SERVICE BULLETIN

MODEL NAME : Di620
MODEL CODE : 1155
NO. : 012
DATE : 981007
SUBJECT : TAKE-UP MISFEED IN C-304L

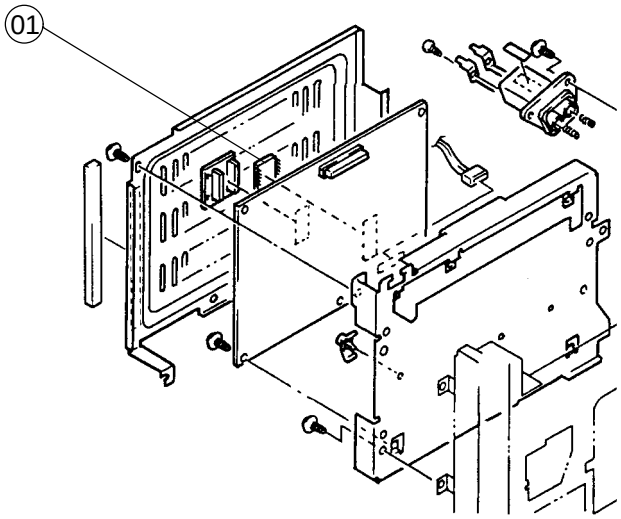
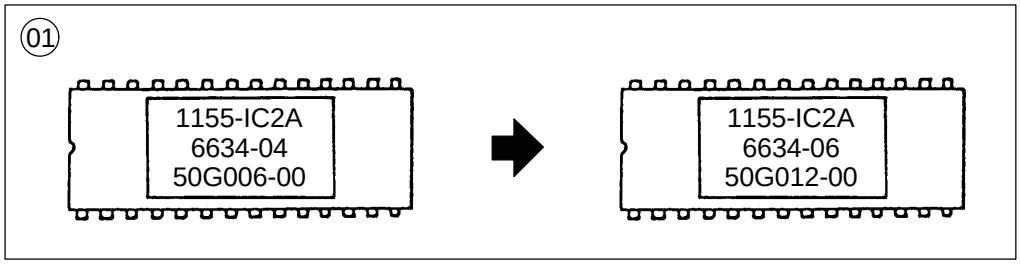
PROBLEM: In the C-304L, there is a possibility that the paper feed motor may be driven erroneously (backward), causing a take-up misfeed to occur.
CAUSE: There is a bug in the software program.
SOLUTION: The software program of IC2A (01) on P.W. Board-A has been changed.

NO.	BEFORE MODI. F-IND	BEFORE MODI. PART NO.	AFTER MODI. PART NO.	AFTER MODI. F-IND	PART NAME	QTY →	I	SE/NO.	AREA
01	36-31AA	1155-6634-04	1155-6634-06	36-31AB	IC	1	1 Y	001539	0000
